**FINAL DRAINAGE REPORT
FOR
STERLING RANCH FILING NO. 2**

**May 2021
Project No. 25188.01**

Engineering Review

PCD File No. SF-20-015

STERLING RANCH EXISTING DRAINAGE MAP

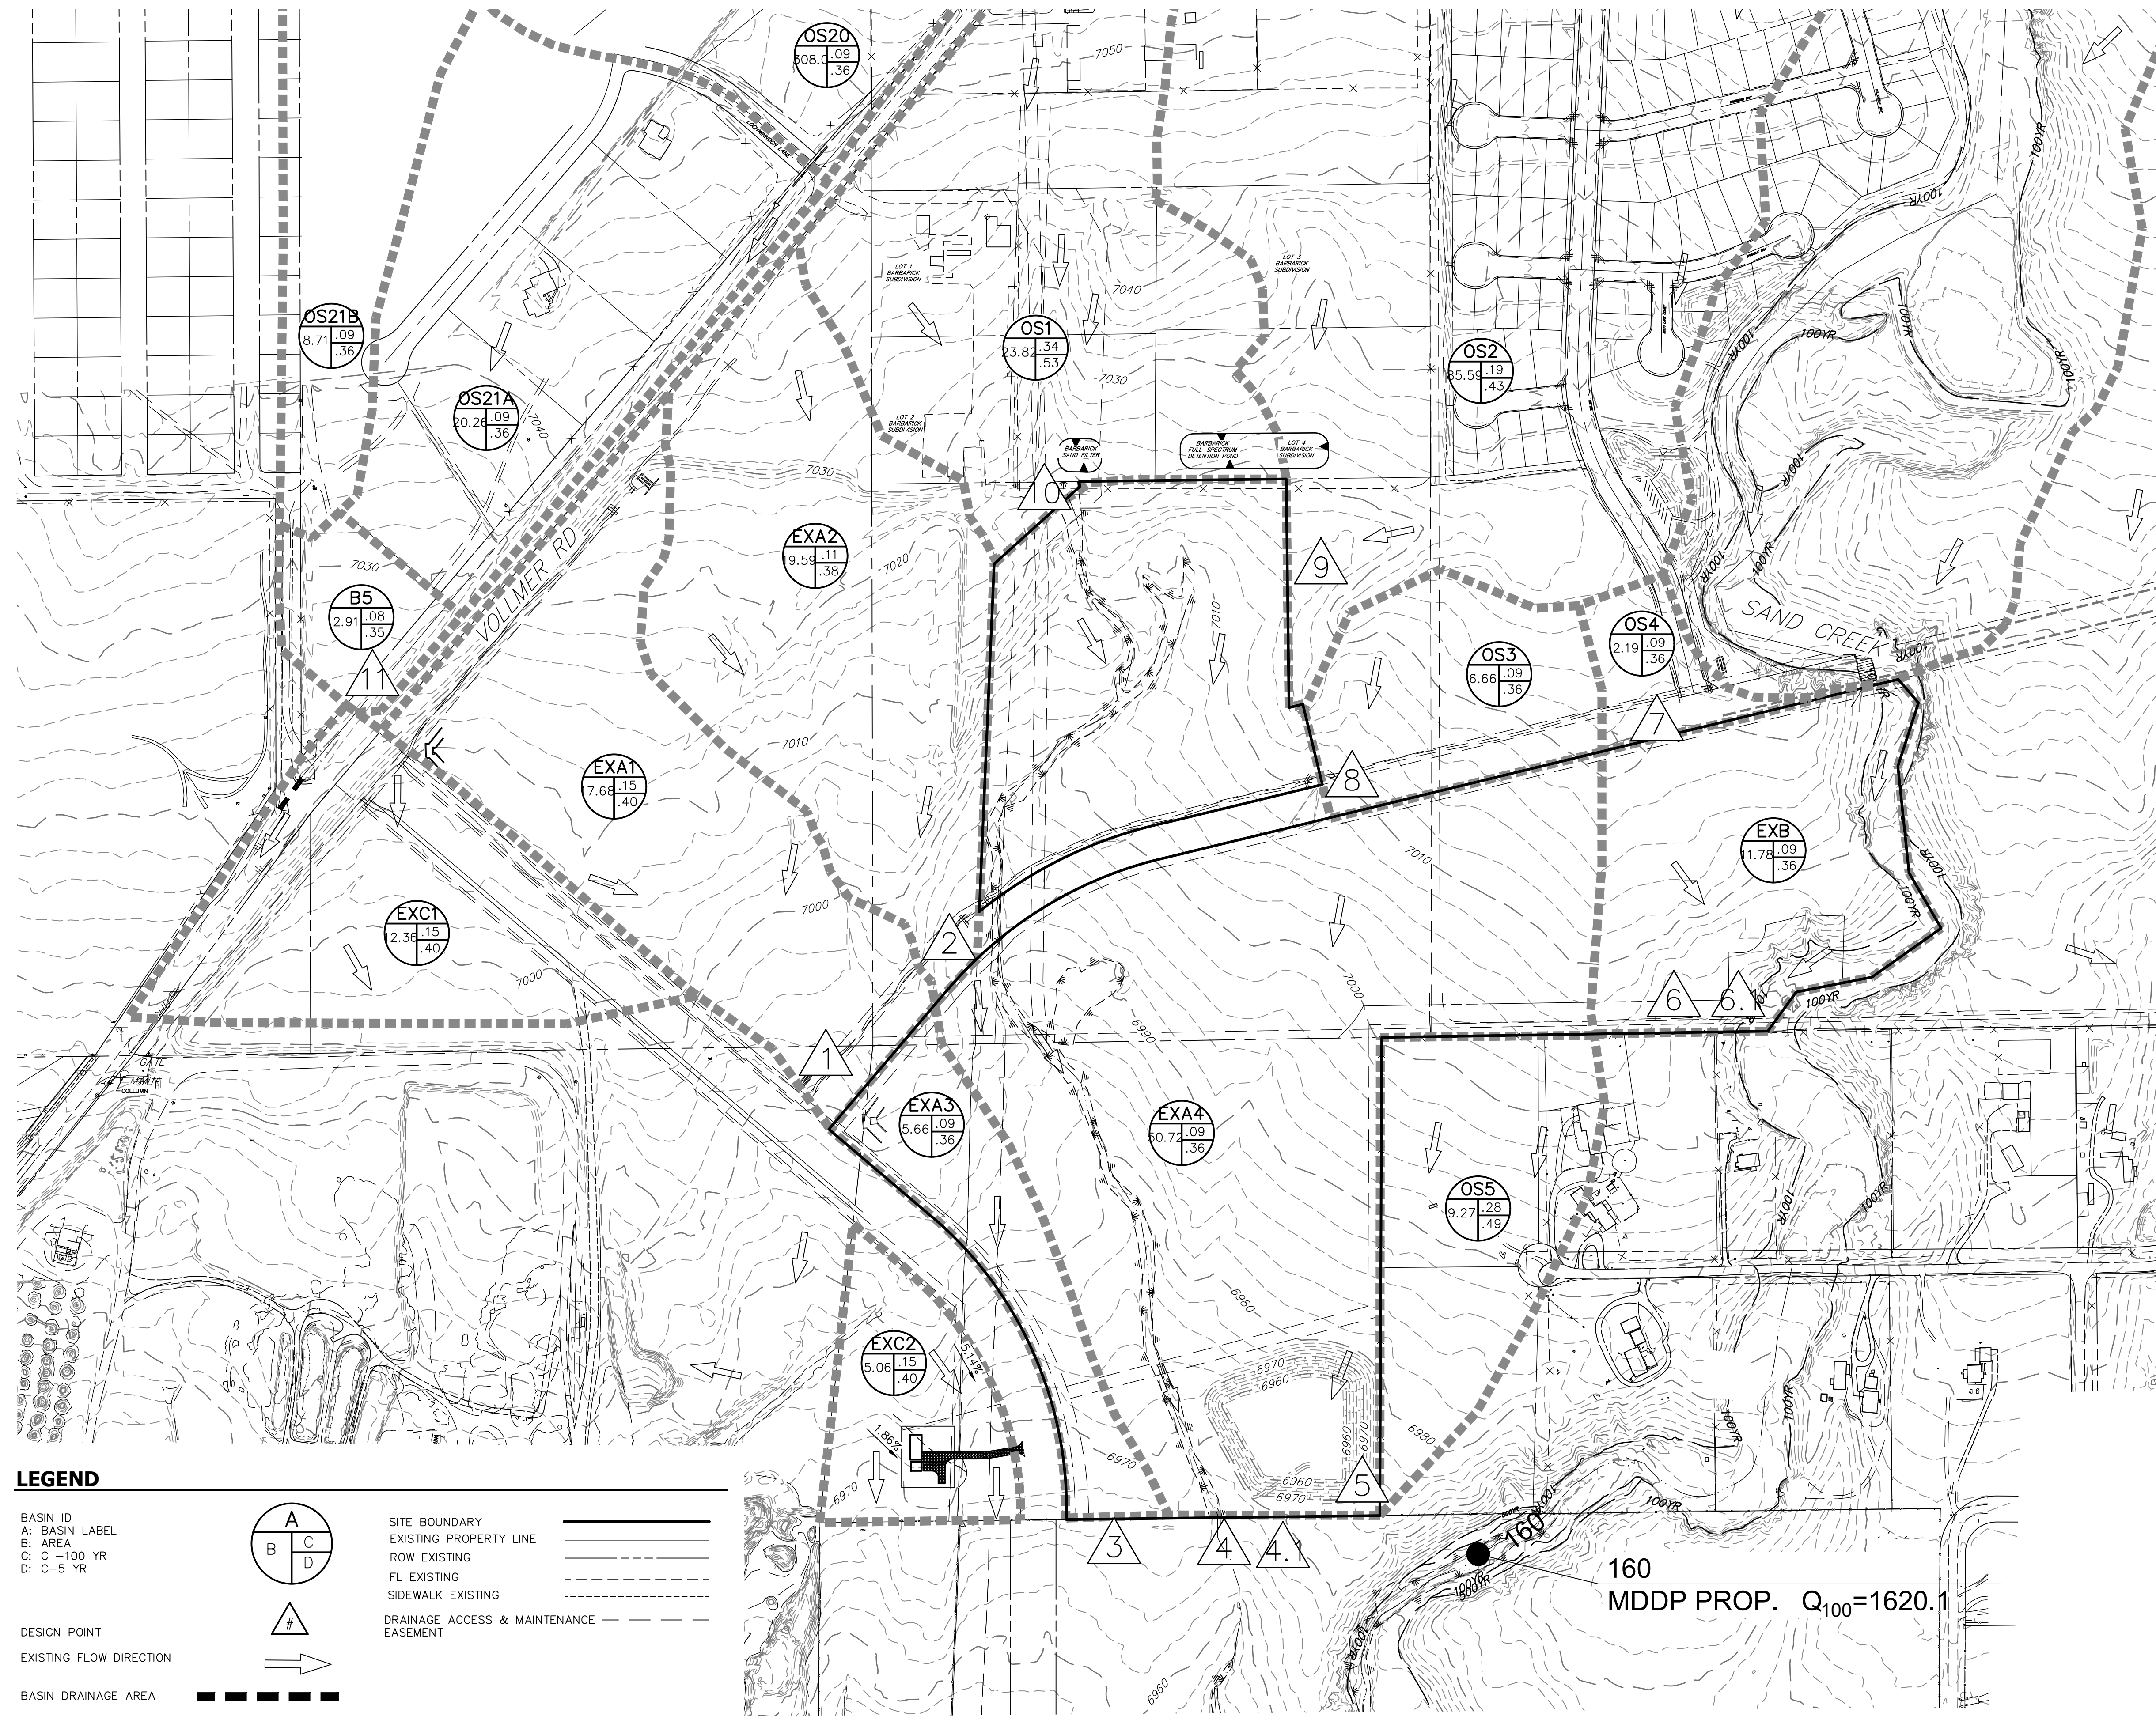
replace Sand Creek DBPS Improvements plan and add proposed improvements plan(s) from Drainage Board presentation (at least pages 18, 20, and 23).
